Re: Draft Environmental Document for the Highway 101 HOV Project

Thank you for this opportunity to comment on the Draft Environmental Document for the Highway 101 HOV Project from Carpinteria to Santa Barbara. By way of background, the Montecito Association has been actively engaged in the review of this project during the last several years. We have met numerous times with Caltrans and Santa Barbara County Association of Governments personnel to discuss project alternatives and community concerns. Our goals have been to ensure that the project is constructed in a manner that preserves community character and aesthetics and minimizes disruption to the community. Our review of the project and document have focused primarily on the segment from Santa Barbara to Summerland, however many of these comments are relevant to the project as a whole.

Figure 1.  
Expanded Cabrillo/Hot Springs Roundabout  
Conceptual Design

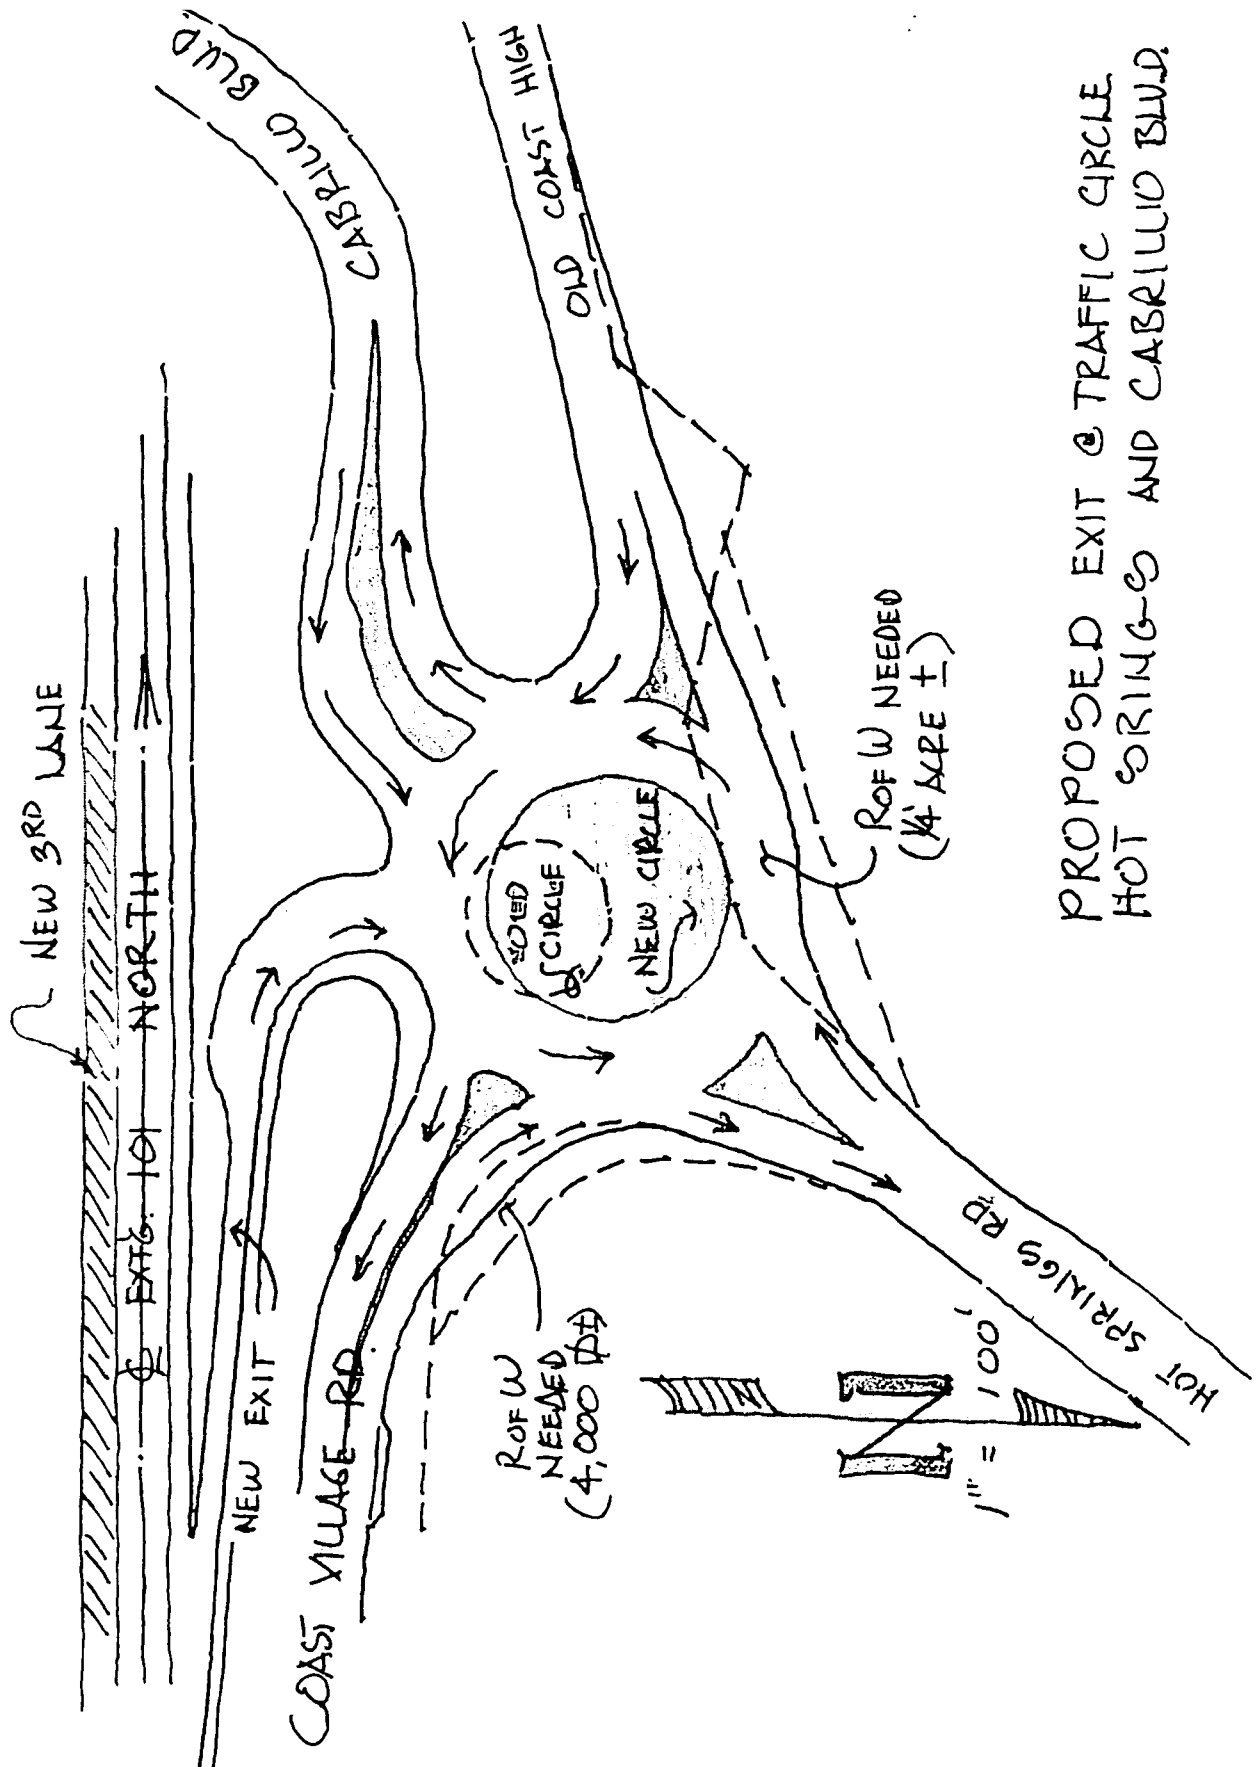
Similarly, the document fails to evaluate an alternative at Cabrillo/Hot Springs that directly connects a new northbound off-ramp to an enlarged Hot Springs roundabout. A draft schematic of this alternative is included as Figure 1 of Exhibit A. Such an alternative would require limited right-of-way acquisition on the north side of the roundabout but would reduce potentially significant concerns (described below) regarding safety and congestion associated with Alternatives F-modified and M.

2. Northbound off ramp directly into expanded roundabout – See Figure 2. The Cabrillo/Hot Springs roundabout would be expanded to carry two lanes of traffic, requiring some right-of-way acquisition to the north. This alternative addresses the northbound off ramp only and does not address the southbound configuration.

Figure 3.  
San Ysidro Interchange  
Conceptual Design

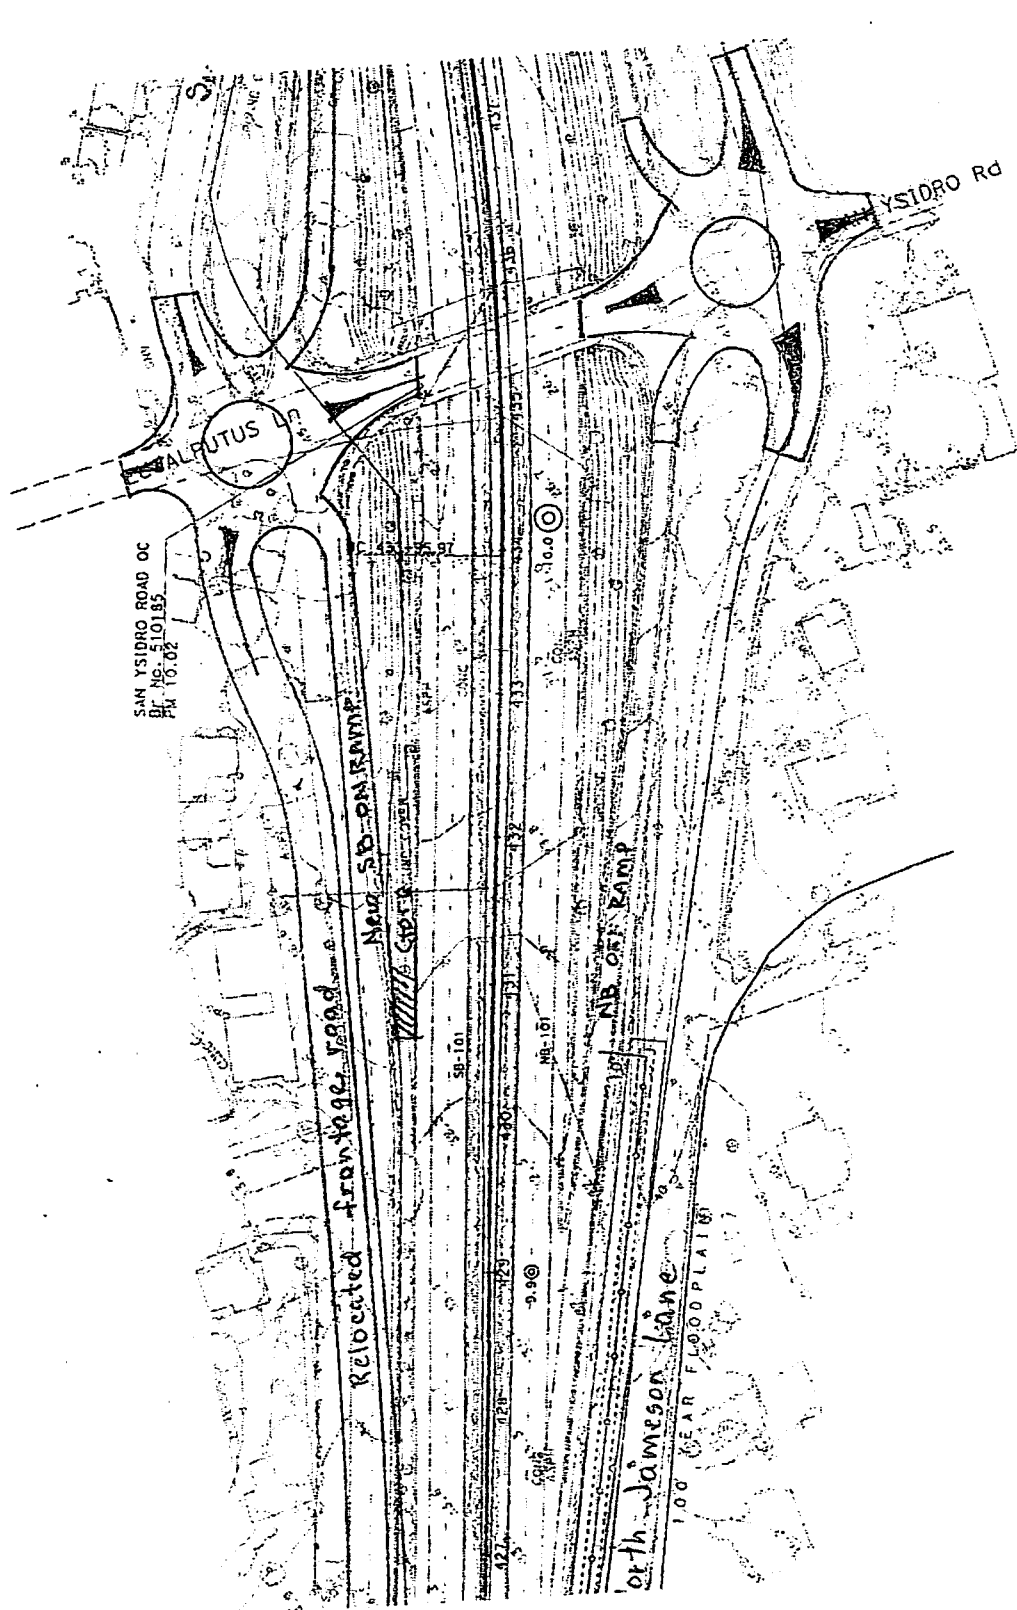
The document should disclose that the existing San Ysidro southbound onramp is extremely dangerous due to the minimal distance provided for vehicles to accelerate. Additional traffic from the approved Miramar Hotel project will add further traffic at this location further exacerbating traffic safety. The proposed project is deficient in failing to consider measures to correct this condition and upgrade the San Ysidro Road overpass. The close proximity of the southbound Olive Mill onramp and the southbound San Ysidro Road offramp currently provide little room for merging traffic, resulting in unsafe conditions. Please document this existing safety condition and propose mitigation measures. We believe that one possible mitigation measure would be the provision of an auxiliary lane in this location, which Caltrans’ own studies indicate would improve 2020 level of service from LOS E to LOS C.

Improve overpass and improve southbound on ramp. One concept includes a new southbound on ramp and a roundabout at each end of the overpass as shown in Figure 3. This dumbbell arrangement would compensate for the inadequate overpass width, which has no provision for a left-turn lane.
